**MEETING OF
THE HISTORIC DISTRICT COMMISSION
PORTSMOUTH, NH**

April 07, 2021

AGENDA (revised on April 01, 2021)

1 OVERALL PLAN - 1ST FLOOR W/ RAMP HDC
1/8" = 1'-0"

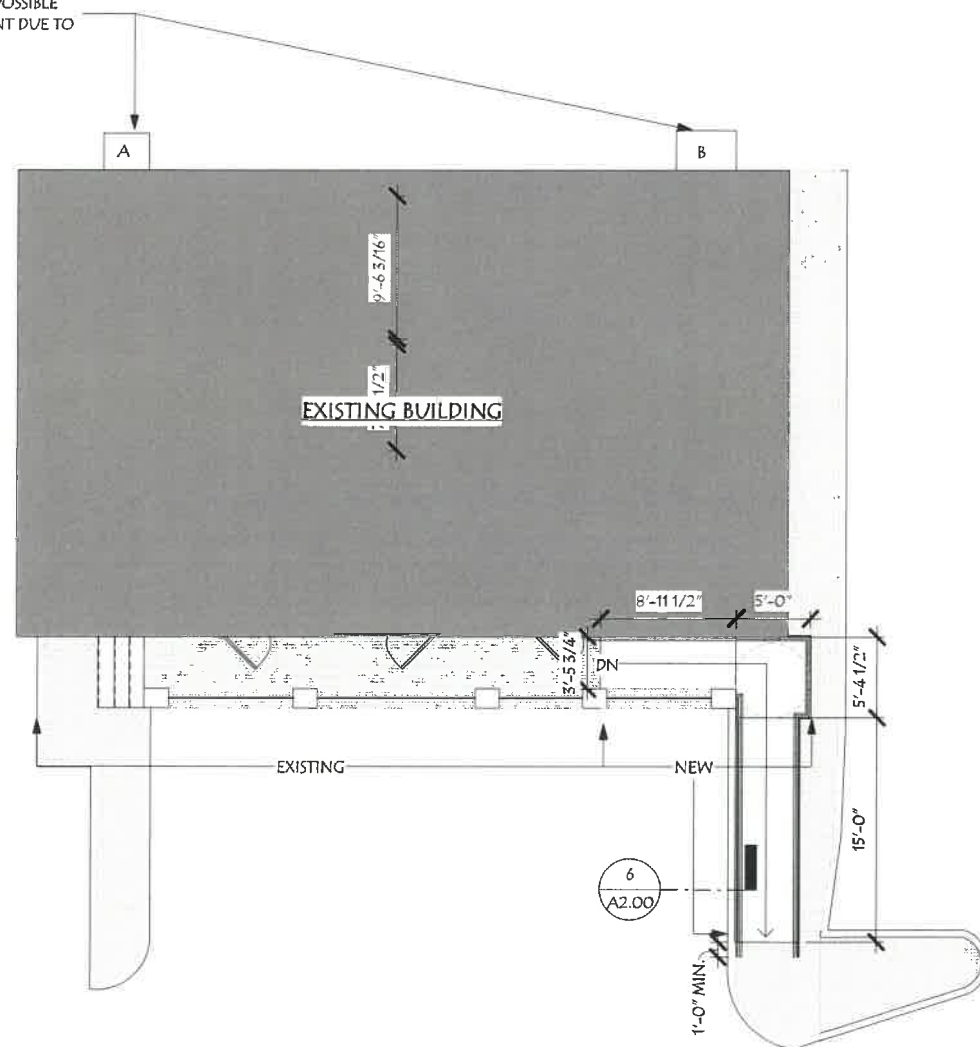
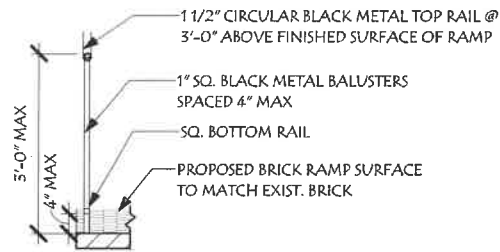
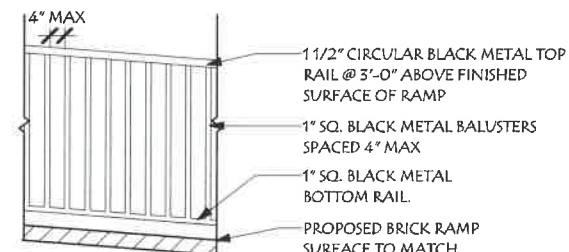
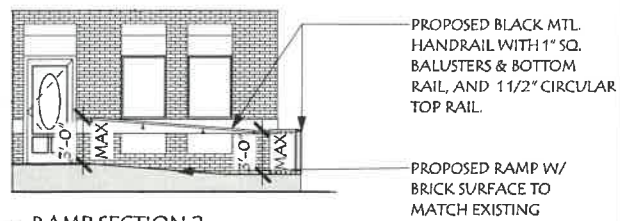
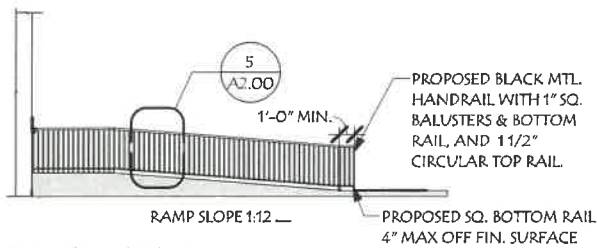
We are looking for administrative approval as a follow up to our initial HDC Approval Meeting on the 2nd of December 2020. The board had requested we provide additional information on the proposed screening of the new HVAC Condensers. We are planning to match that of the rest of Noble Island behind Building #2. We will provide a (3) sided screening so that the unit is screened from the neighbors and from Market Street as discussed.

The Board of Directors also approves of the replacement of the two condensers shown in the Market Square design plans. The Board requests replacement of the existing corral and the installation of a corral around the condenser that does not already have one. The corral needs to be constructed in like-kind and painted to match all other corrals around the property.

Contextual Map from Portsmouth 3D Map

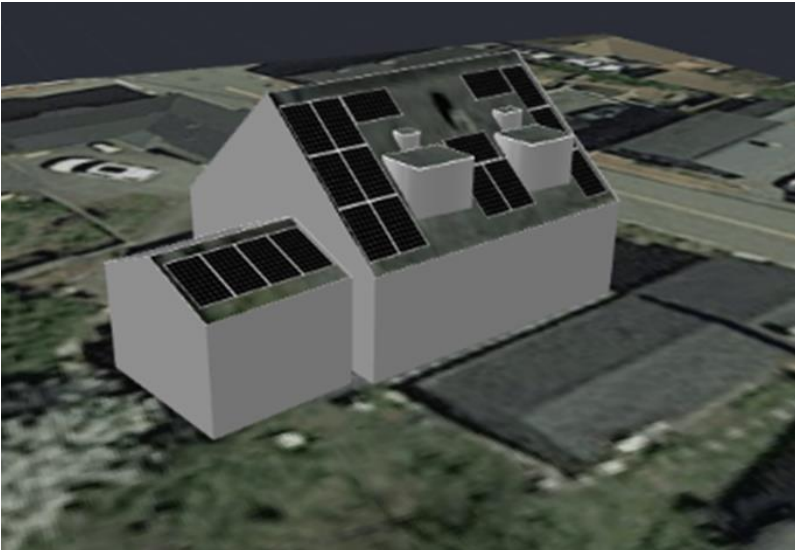
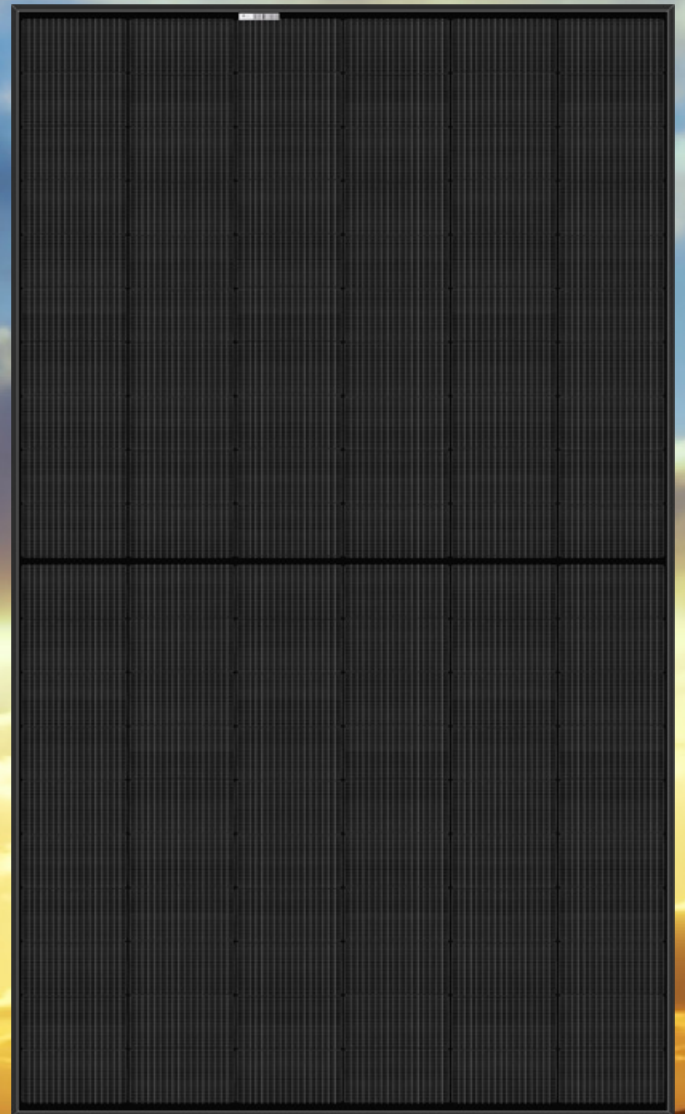
Mr. Adams asked what kind of modifications had to be done to the roof to support the installation. Mr. Hackett said any necessary changes would be made to the interior space of the roof. Mr. Adams asked about a frame. Mr. Hackett said the panels would not have to be angled due to the roof's pitch, so they would be flush-mounted and 2-3 inches to the roof.

This application is to install 18 60-cell solar panels on the south roof of 238 Marcy Street. This project will generate 6.6 kilowatts, roughly 75% of the building's current annual electrical power. The proposed solar panels are REC Alpha Black Series 370s, which are constructed from non-glossy materials with a full-black matte finish and hidden wiring preferred by designers where glossy panels are considered inappropriate.
